MURRAY BELL PLANNING CO.

Date: 13 November 2026
Ref: A006522634

RE: MINOR CHANGE TO A DEVELOPMENT APPROVAL
DEVELOPMENT PERMIT FOR MATERIAL CHANGE OF USE - ROOMING ACCOMMODATION AND SHORT-TERM ACCOMMODATION
2, 6, 8 AND 10A RICHMOND ROAD, MORNINGSIDE QLD 4170

Figure 1 – Proposed (Left) and Approved (Right) Rooftop Configuration

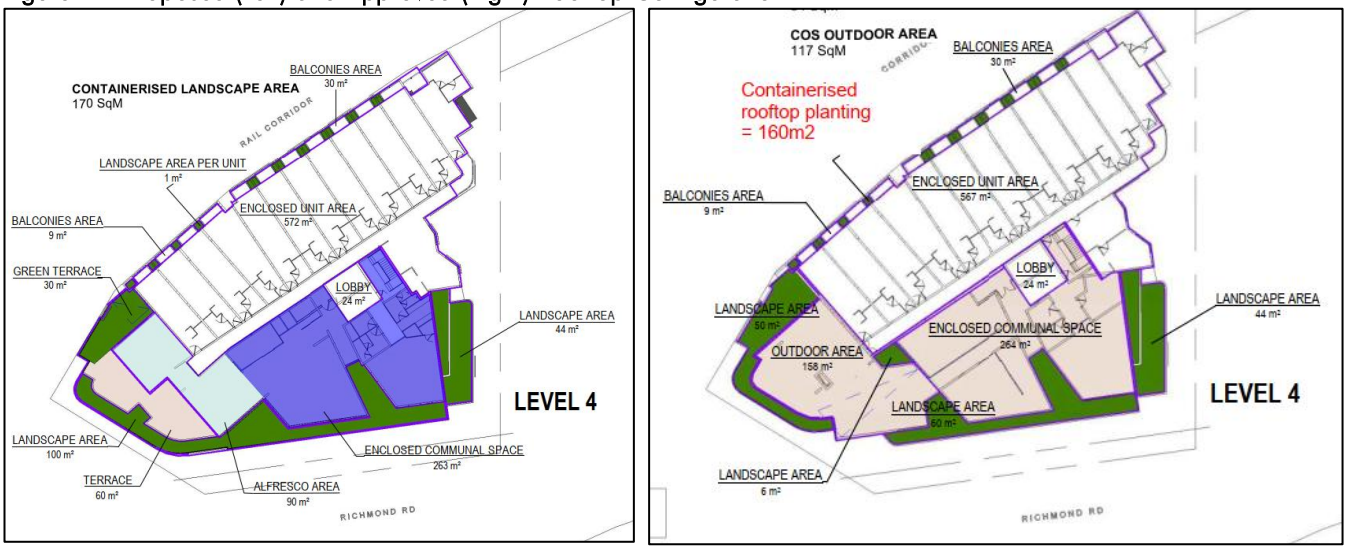
Level 4

In response to feedback from the prospective operator, enhanced weather protection is proposed to the rooftop lounge and kitchen area to improve the functionality and year-round usability of the communal facilities. Operable stacking doors are proposed around the outer perimeter of the lounge and kitchen area. These doors will allow the communal facilities to be enclosed during inclement weather and opened to the adjoining terraces during favourable conditions. This will enable residents to use the lounge and recreation areas more consistently, rather than only when weather conditions are suitable for outdoor rooftop recreation. The alterations will have a negligible effect on the appearance, bulk and scale of the building while significantly improving the functionality and amenity of the communal facilities.

The rooftop landscaping has also been reconsidered to provide a more consistent and higher-amenity edge to Richmond Road. A continuous landscaped perimeter is now proposed along the frontage, improving the building's presentation to the street and providing a greener outlook from the communal facilities.
